Subject: FW: Question for Ms. Knack at next ANAC meeting

Subject: FW: Discontinuity in noise impacted area

Subject: FW: Noise abatement? Please distribute to ANAC members

Subject: FW: airportcapacity

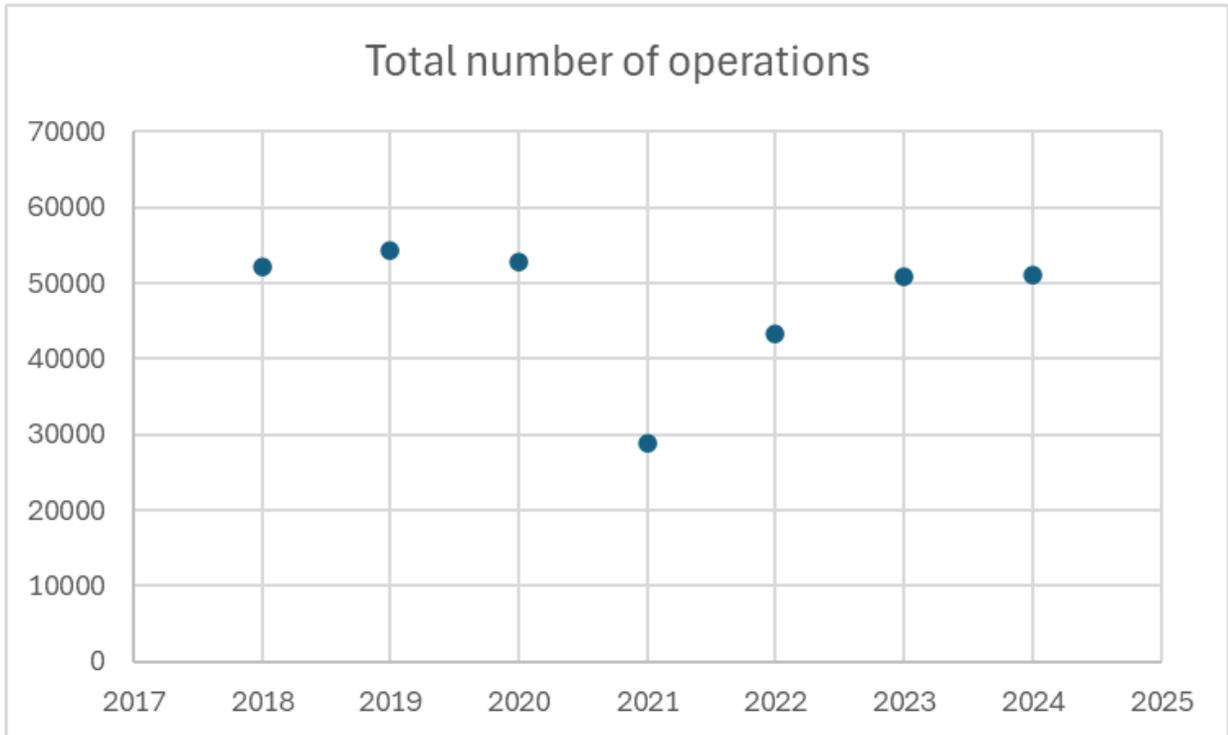
According to Flightradar24, there were 35 aircraft scheduled to depart by 7 am and yet less than 20 actually departed. Why are these aircraft allowed to schedule so early knowing that there is no chance they will get away on time? The number of departures was maximized during the first half hour by delaying arrivals until 7 am, but still the maximum number of departures is 25 according to the FAA document, but the numbers.

Noise impacted area by date of calculation

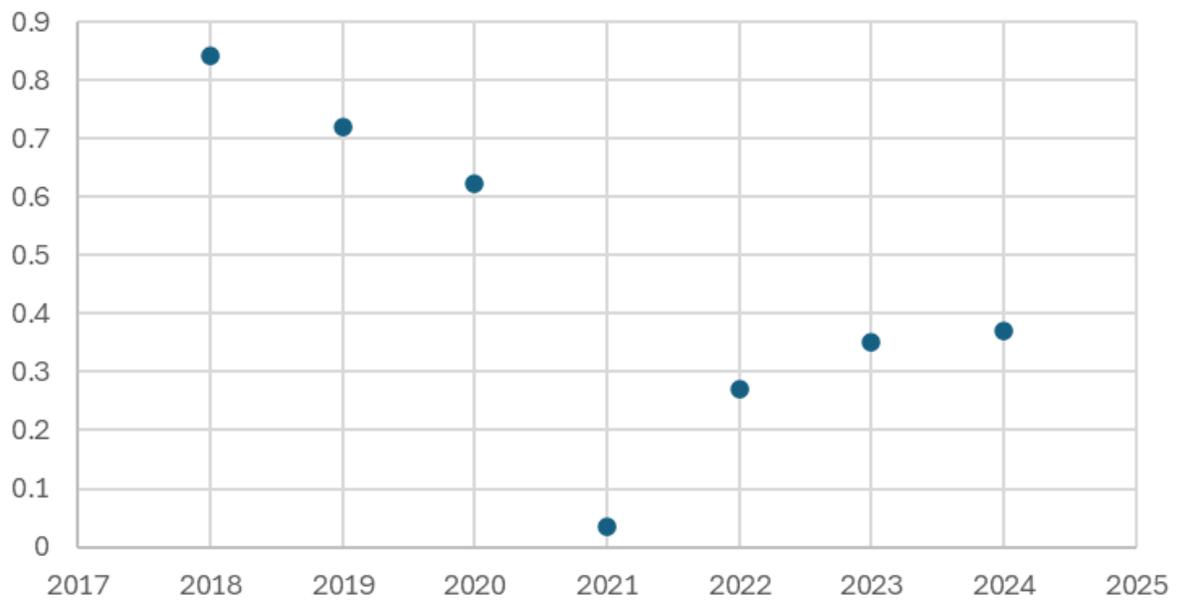
Please distribute to ANAC members. Discounting the effect from the pandemic, can you please explain the discontinuity in the noise impacted area after the pandemic?

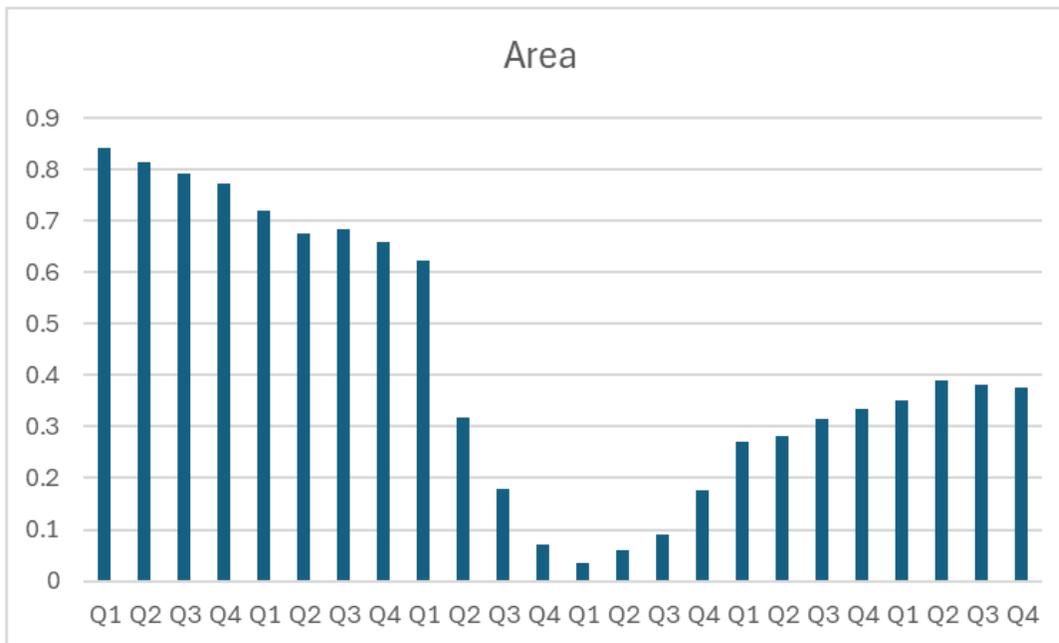
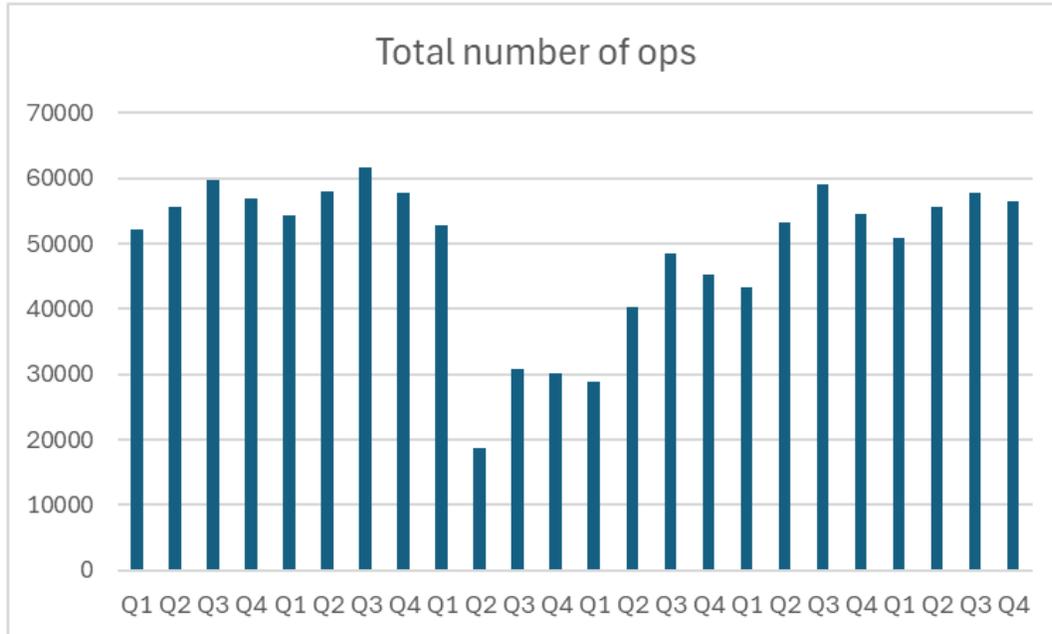
How do you account for the dramatic decrease in the impacted area even though the number of operations is about the same.

MEDIAN ALTITUDE NORTH BOTH TOTAL YEAR AND 7 DAYS DATA 2023 2024

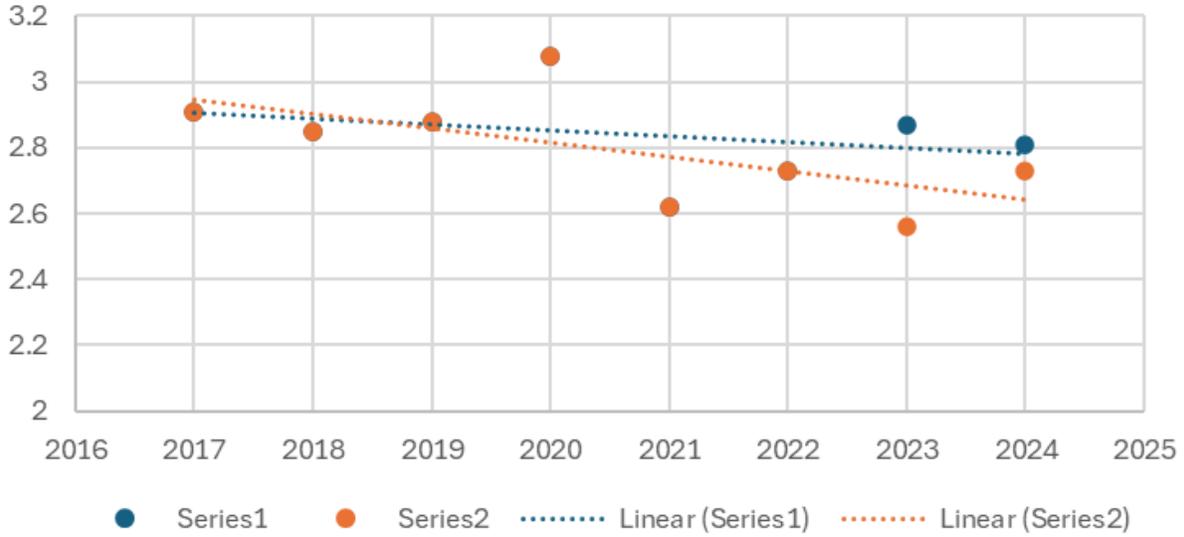
The first chart shows the average altitude for aircraft as they pass over the coast for departures to the north (PADRZ after 2017). There were a number of older aircraft retired during the pandemic in 2021, but not clear why there is a downward trend in altitude?

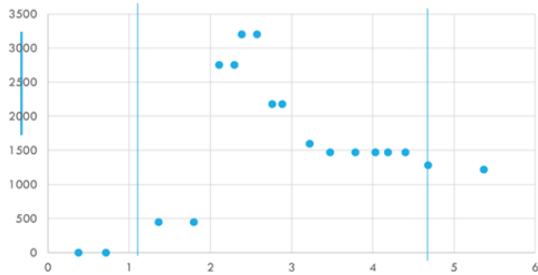
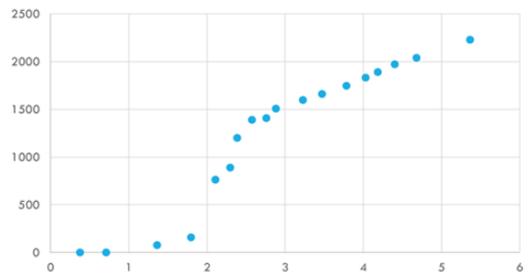
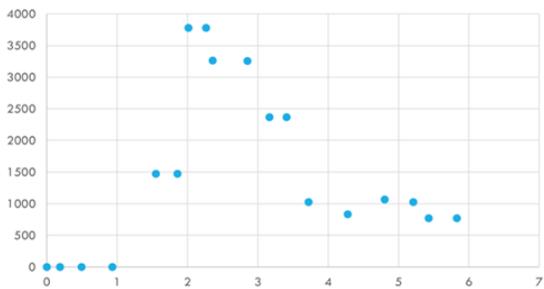
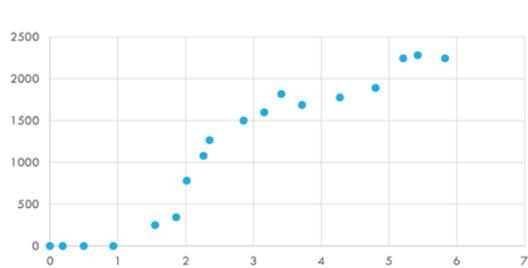
The first chart shows vertical speed (proportional to thrust) and the second one altitude. Do these charts reflect a change in the NADP, and if so, was there a noise abatement benefit in Mission Beach, given that lower thrusts result in noise reduction, but, noise levels on the ground are most sensitive to distance above the ground. If there was a change to the NADP, were noise measurements on the ground taken before and after?
